Access Compliance Report

Public Rights-of-Way

Intersection ID: 3125	Main Street: JOHNSTON_OEHLER_RD	Cross Street: MOURNING_DOVE_LN	Location: NW
ADA ID: D9E65546F296	Ramp Type: Perp	Initial Pass/Fail: Pass	Overall Compliance: No
Severity Score: 0			
Codes/Mitigation Info/Possible Solution		Field Measurements/Component Compliance

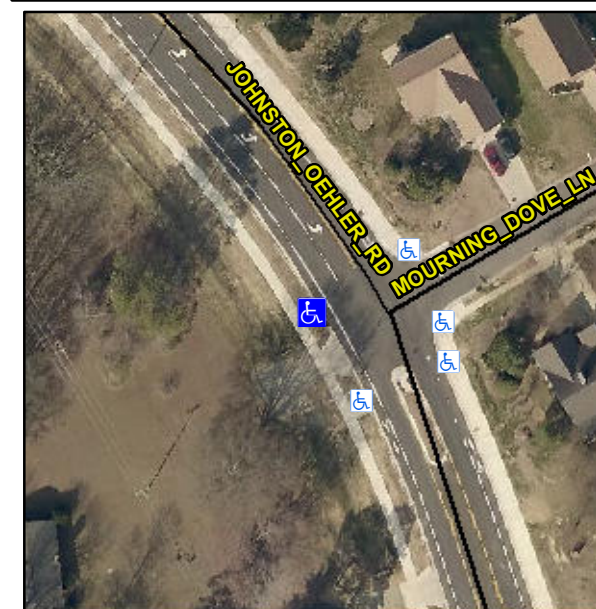
R304.5.3

Compliance	Description	Data	Compliance	Description	Data
N/A	Ramp Length (in)	95.0	Yes	Ramp Slope (%)	6.7
Yes	Ramp Width (in)	93.0	Yes	Ramp XSlope (%)	2.0
Yes	Flare Type LT	Curbed_NoWalkSurface	Yes	Flare Type RT	N/A
Yes	Flare Slope LT (%)	N/A	N/A	Flare Slope RT (%)	N/A
N/A	Flare Traversable LT?	No	N/A	Flare Traversable RT?	No
Yes	Landing Length (in)	72.0	Yes	DWS Provided?	Yes
Yes	Landing Width (in)	98.0	Yes	DWS Contrast?	Yes
Yes	Landing Slope (%)	0.9	Yes	DWS Length (in)	24.0
No	Landing X Slope (%)	2.8	Yes	DWS Full Width?	Yes
N/A	Landing Curb? (Y/N)	No	Yes	DWS Offset (in)	0.0
N/A	Shared Landing?	No			
Yes	Gutter Ponding?	No	Yes	Gutter Slope (%)	0.1
Yes	Gutter Lip Ht (in)	0.0	No	Gutter X Slope (%)	2.9
N/A	Painted X Walk1?	No	N/A	Painted X Walk2?	N/A
	X Walk 1 Direction	To E		X Walk 2 Direction	N/A
N/A	X Walk 1 Width (in)	N/A	N/A	X Walk 2 Width (in)	N/A
	X Walk 1 Slope (%)	0.9		X Walk 2 Slope (%)	N/A
	X Walk 1 X Slope (%)	2.7		X Walk 2 X Slope (%)	N/A

**Remove & Replace Landing.
Remove & Replace Gutter.**
